CHANGE ORDER

Project: **Kittitas County Upper District Court Remodel** KC Project No.: **2012-004**
Owner: **Kitittas County** ART Project No. **1204**
Architect: **Architects Rasmussen Triebelhorn, AIA P/S** Change Order No.: **3**
Contractor: **M. Sevigny Construction, Inc.** Date: **10-Sep-2013**
(☐) No Change (☒) Addition (☐) Deduction

PROPOSAL REQUEST

PROPOSAL REQUEST NO: **24**

ESK-7

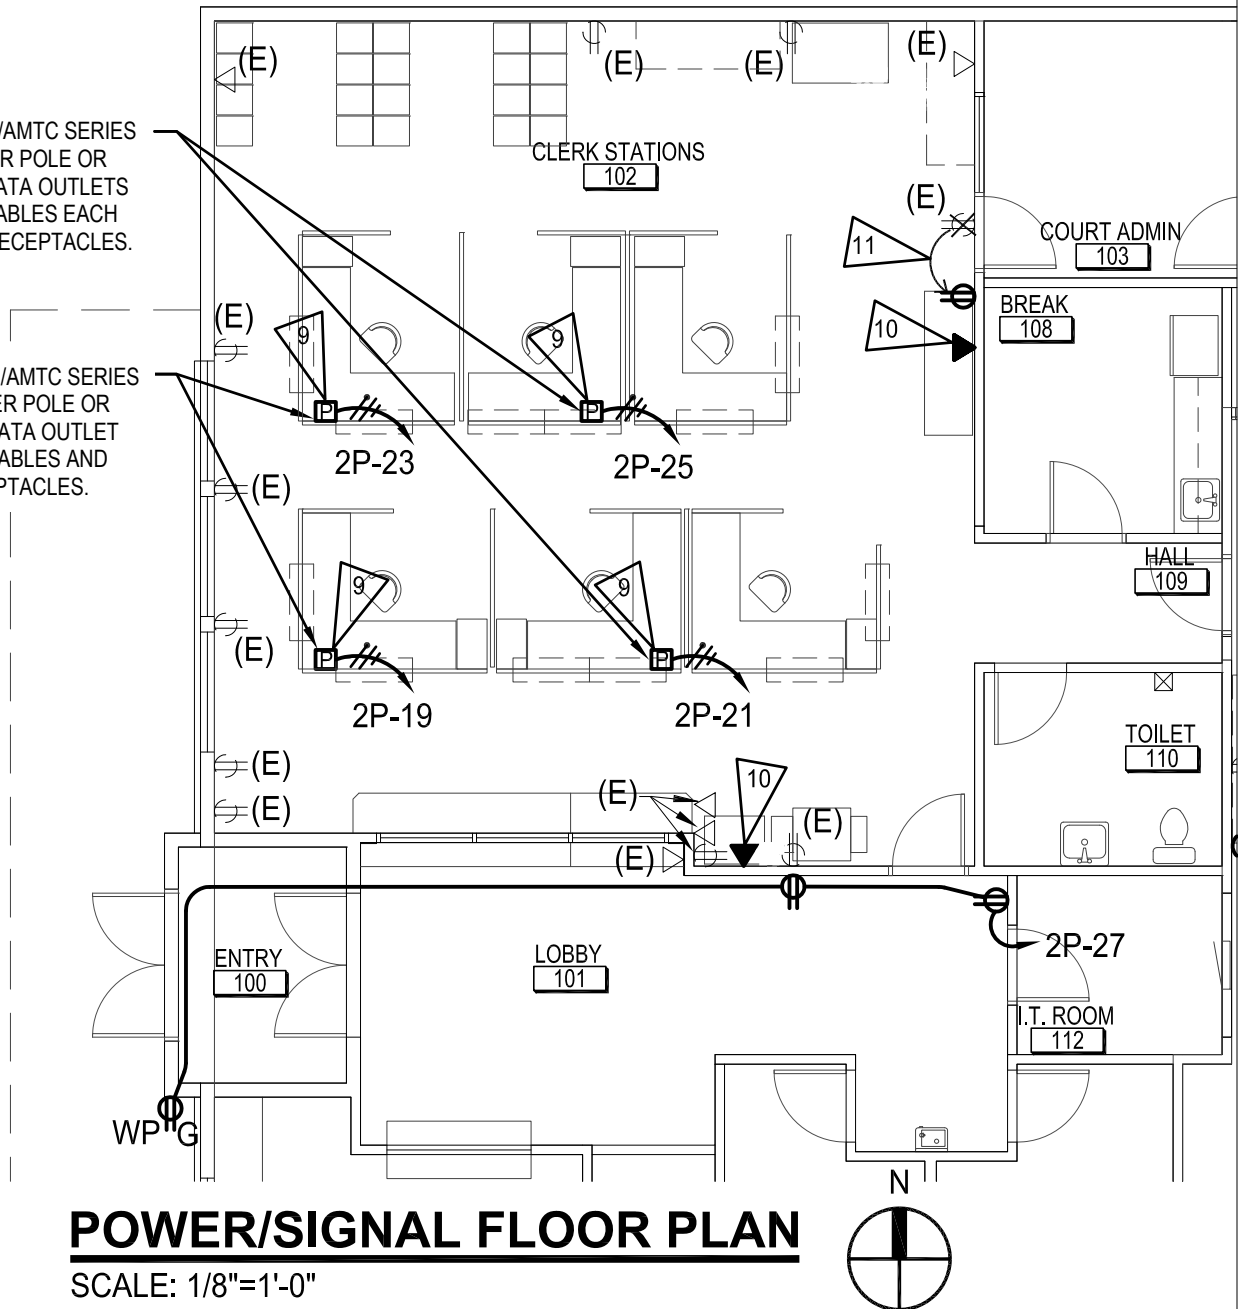
6. Provide a new Chatsworth 46353-503 rack with wire management per ESK-7 and new 24-port patch panel to match existing to accommodate new data cabling.

ESK-6

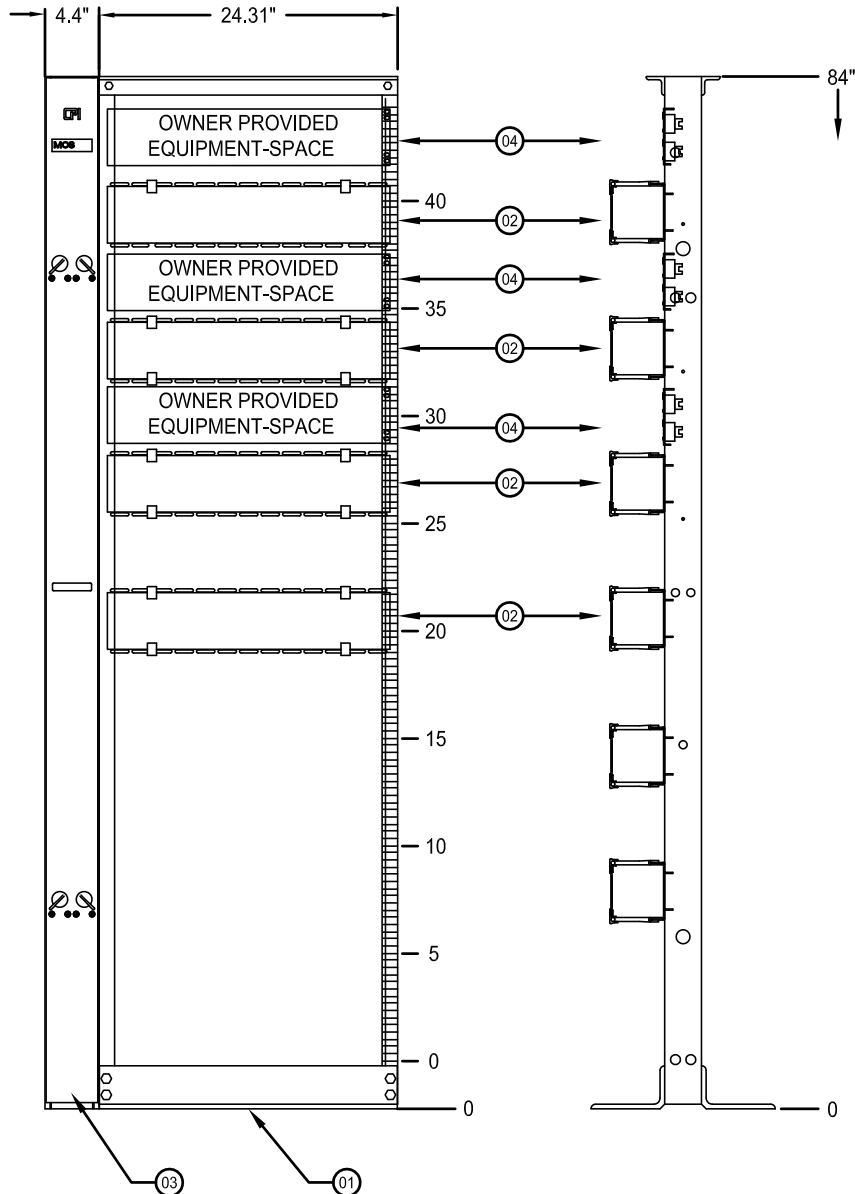
Revise the power, telephone and data within Clerk Stations 102 as shown in the attached power/signal floor plan, and as outlined below.

1. Provide (4) Wiremold 25DTP/AMTC series power poles in lieu of (4) discontinued NP600 wiremold power poles, in revised locations shown on attached plan. Exact locations to be coordinated by Owner/Architect in field prior to final placement. (2) power poles shall have (4) duplex receptacles and (2) data outlets with (3) Cat 5e cables to each. (2) power poles shall have (4) duplex receptacles and (1) data outlets with (3) Cat 5e cables to each.

2. Delete and provide credit for all 2-channel wiremold from west wall, including (2) 4-plex receptacles, (2) data outlets and associated conduit and wire.

3. Relocate (1) existing duplex receptacle impacted by the installation of the door and relite to Court Admin 103 southward to wall in common with Break 108. Provide 1/2"C-#12 CU Conductors and reconnect to existing circuit.

4. Contractor shall provide (2) Cat 5e cables to all existing data locations in Clerk Station 102.
5. Add (2) analog phone receptacles at locations shown. Wiring shall be routed to phone demarcation location. Provide surface wiremold from above ceiling to new surface mounted analog phone outlet for wiring.

- 9 POWER POLE LOCATION ARE DEPENDANT ON FURNITURE LOCATIONS. CONTRACTOR SHALL VERIFY LOCATION OF POWER POLES WITH OWNER PRIOR TO FINAL INSTALLATION.
- 10 CONTRACTOR SHALL PROVIDE AN ANALOG PHONE LINE AT THIS LOCATION FOR FAX OR POSTAGE METER.
- 11 CONTRACTOR SHALL PROVIDE 1/2"C-#12 CU CONDUCTORS AND RELOCATE EXISTING RECEPTACLE TO WITH-IN 1 FOOT OF NEW DOOR JAM.

WIREMOLD 25DTP/AMTC SERIES
2-CHANNEL POWER POLE OR
EQUAL WITH (2) DATA OUTLETS
WITH (3) CAT 5e CABLES EACH
AND (4) DUPLEX RECEPTACLES.

WIREMOLD 25DTP/AMTC SERIES
2-CHANNEL POWER POLE OR
EQUAL WITH (1) DATA OUTLET
WITH (3) CAT 5e CABLES AND
(4) DUPLEX RECEPTACLES.
